From: Gilmore, Tyler J [Tyler.Gilmore@pnnl.gov]
nt: Friday, January 17, 2014 4:06 PM
): McDonald, Jeffrey
Cc: Greenhagen, Andrew
Subject: Re: Informal Request (IR) # 3 (IR3-01-10-14)
Attachments: EPA_IR3_for_FG-RPT-017-Final.pdf

From: <McDonald>, Jeff McDonald <mcdonald.jeffrey@epa.gov>
Date: Friday, January 10, 2014 12:38 PM
To: Tyler Gilmore <tyler.gilmore@pnnl.gov>
Cc: "Greenhagen, Andrew" <Greenhagen.Andrew@epa.gov>
Subject: Informal Request (IR) # 3 (IR3-01-10-14)

01-10-2014: Email from Jeff McDonald (U.S. EPA Region 5) to Tyler Gilmore (Alliance). Informal Request (IR) #3 (IR3_01_10_14)				
Requests based on the text application				
IR #	Subject	Page	Doc. Sec.	Par.
01-10-2014_1	Alternative PISC timeframe	7.1	7.0	<p>"It appears that FutureGen will not be making a demonstration for an alternative PISC period (other than the 50 year default). We assume that if FutureGen makes a demonstration for a PISC other than the 50 year default, this will happen in the future. Is this correct?"</p>
01-10-2014_2	Testing and Monitoring	5.25	5.2.3.3	<p>"This bullet point states that pressure gauges will be pulled and recalibrated during a well workover, when the injection and monitoring well

Determination of the Top of the Injection Zone, based on Geophysical Logs and Modeling Results

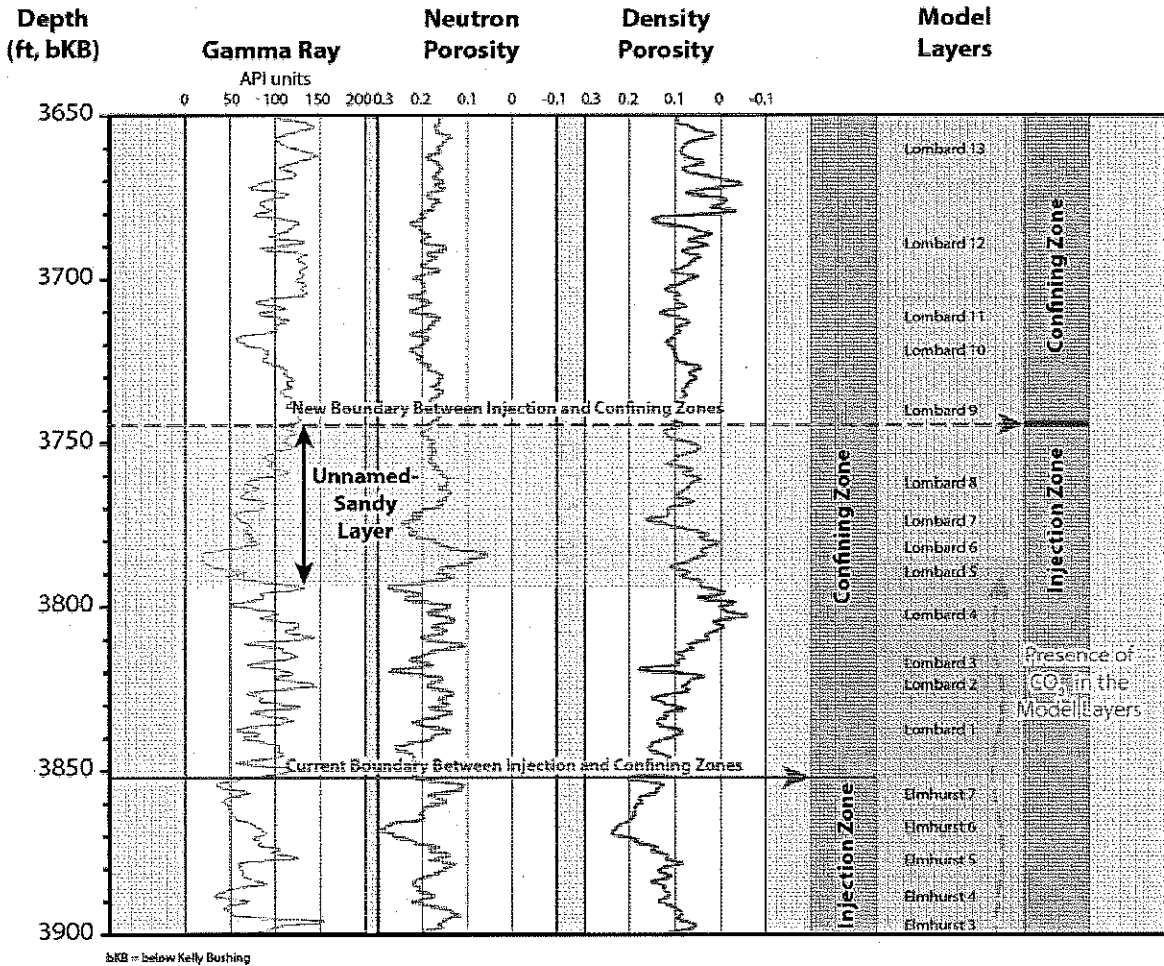
01-10-2014 Email from Jeff McDonald (U.S. EPA Region 5) to Tyrel Gilmore (Alliances): "Informal Request (IR) #3 (IR3_01_10_14)"						
Requests based on the text application						
IR #	Subject	Page	Doc. Sec. Par.	EPA Comment/Question/Request	FutureGen Response	Footnote / Reference Citation
01-10-2014_5	PISC	3.27 to 3.34	7.1.3 and 3.1.6	"The computational model results indicate that a small fraction of the injected CO ₂ will enter the lower part of the Lombard formation. If authorized under any UIC permits, the injection zone will need to include that lower part of the Lombard. Please determine what members or submembers of the Lombard are expected to receive CO ₂ and will therefore be part of any permitted injection zone."	The computation model results indicate that the Model Layer "Lombard 5" is the top unit containing a fraction of injected CO ₂ during the 100-year simulation. However, because geophysical logs indicate the presence of an unnamed thin sandy layer above Lombard 5 (see graphic in Appendix A), the Alliance determined that this thin sandstone should also be part of the injection zone. In conclusion, based on the current knowledge of the geology at the FGA1 stratigraphic well, the top of the injection zone is set at 3,745 ft KB (or 3,731 ft below ground surface), which is in the lower part of the model layer "Lombard 5" (Appendix A). KB = below Kelly Bushing

Figure 2. Updated and Revised Plan for Monitoring Wells.

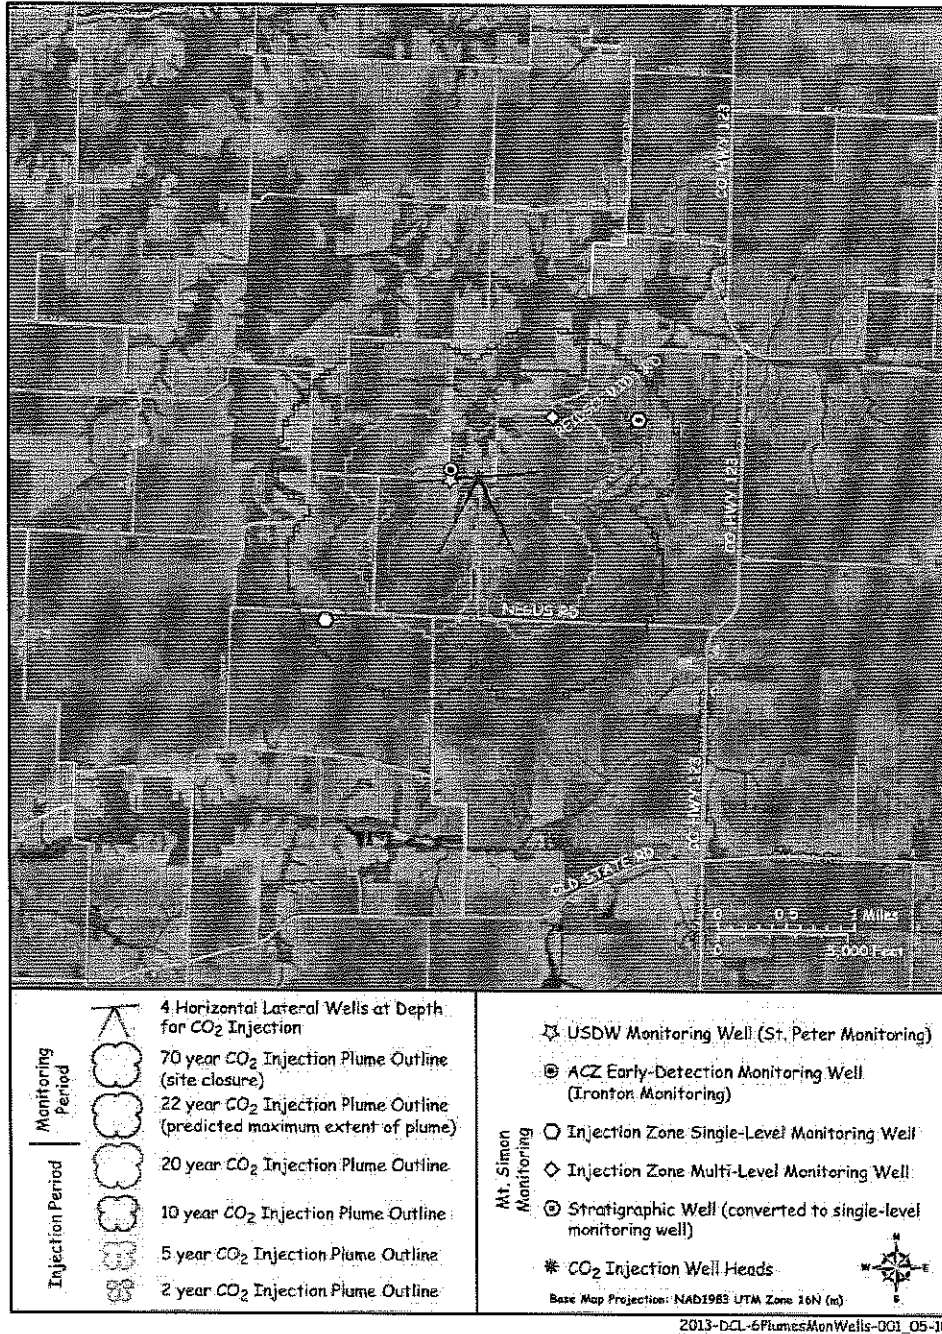
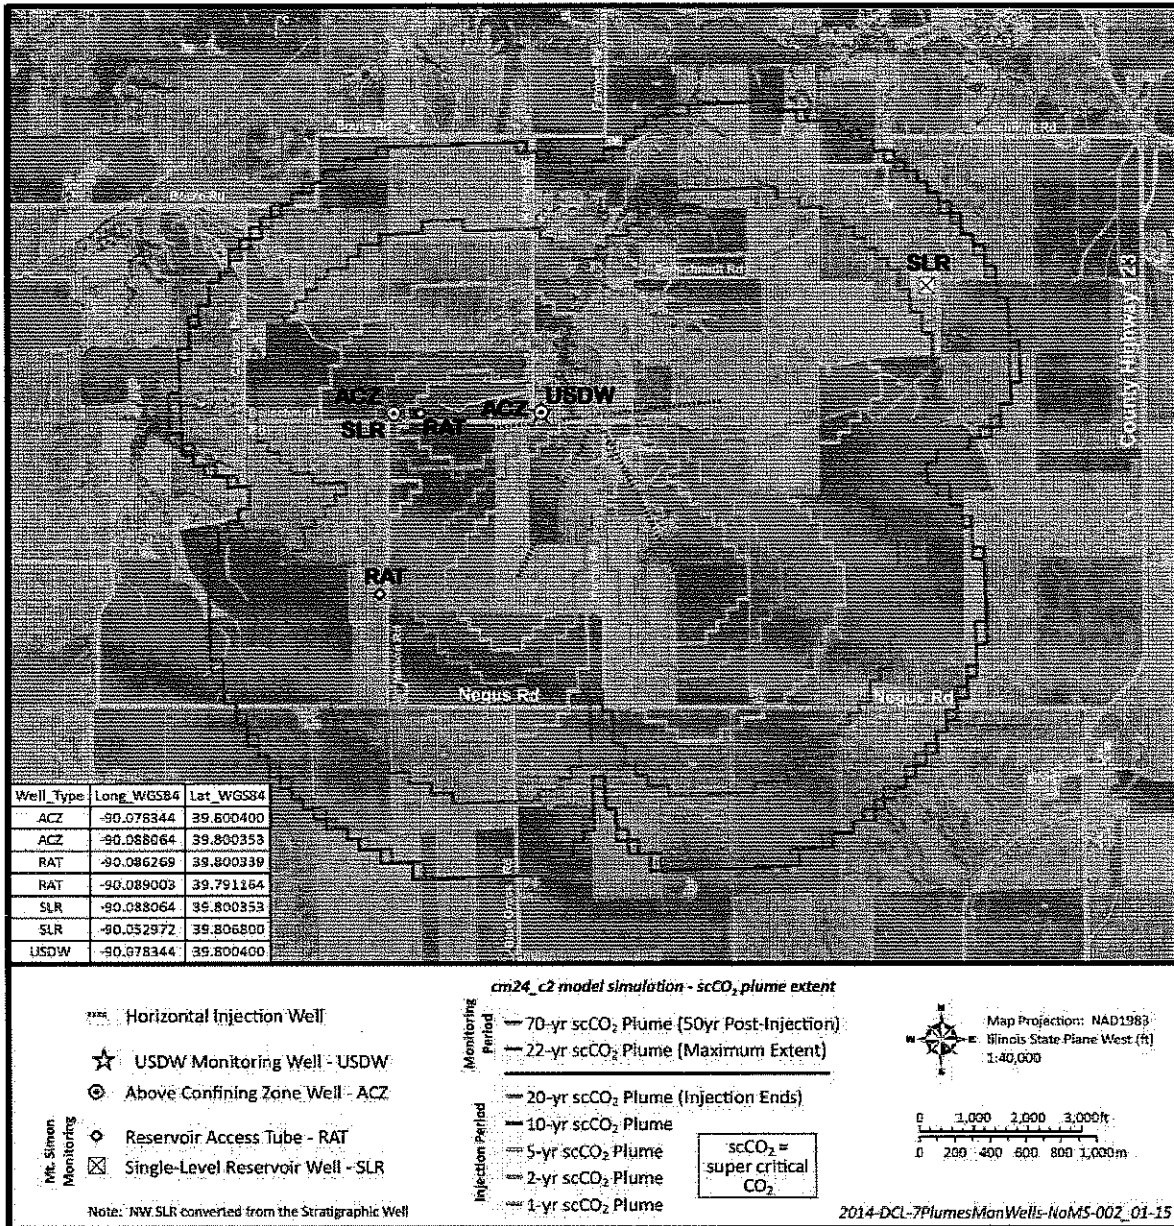
01-10-2014_6	PISC and T&M	7.5	7.2 and 5.2	"Specific locations of monitoring wells need to be identified for any permit decision including what specific parameters will be monitored for."	The Alliance has modified the monitoring network design since the UIC permit application was submitted. A discussion, which includes monitored parameters, and a location map showing the updated and revised monitoring well network are provided in Appendix B.	
01-10-2014_7	PISC and T&M	7.5	7.2.2	"Please state whether FGA will use a "multi-level monitoring system within a single casing string with multiple sample intervals" or a "multi-level piezometer installation.""	The Alliance has modified the monitoring network design since the UIC permit application was submitted by eliminating this "multi-level monitoring well". The previously planned multi-level completion has been replaced by two fully cased reservoir access tubes (RATs) that will be installed within the boundaries of the simulated 5-year CO ₂ plume. The RATs will extend to the base of the reservoir and into the Precambrian bedrock. The RATs will be non-perforated, cemented casings used to monitor CO ₂ arrival and quantify saturation levels via downhole pulsed-neutron capture (PNC) geophysical logging across the reservoir and confining zone. A discussion and location map showing the updated and revised monitoring well network is provided in Appendix B.

As part of the project's design optimization, the monitoring well network design has been revised (Figure 2) to increase its effectiveness, simplify its engineering design, and hopefully eliminate any permitting challenges that might have been associated with the MLR. The revisions include eliminating the MLR well in favor of adding two fully cased reservoir access tube (RAT) wells. The revised design includes a total of seven monitoring wells summarized in Table 1 and as follows:
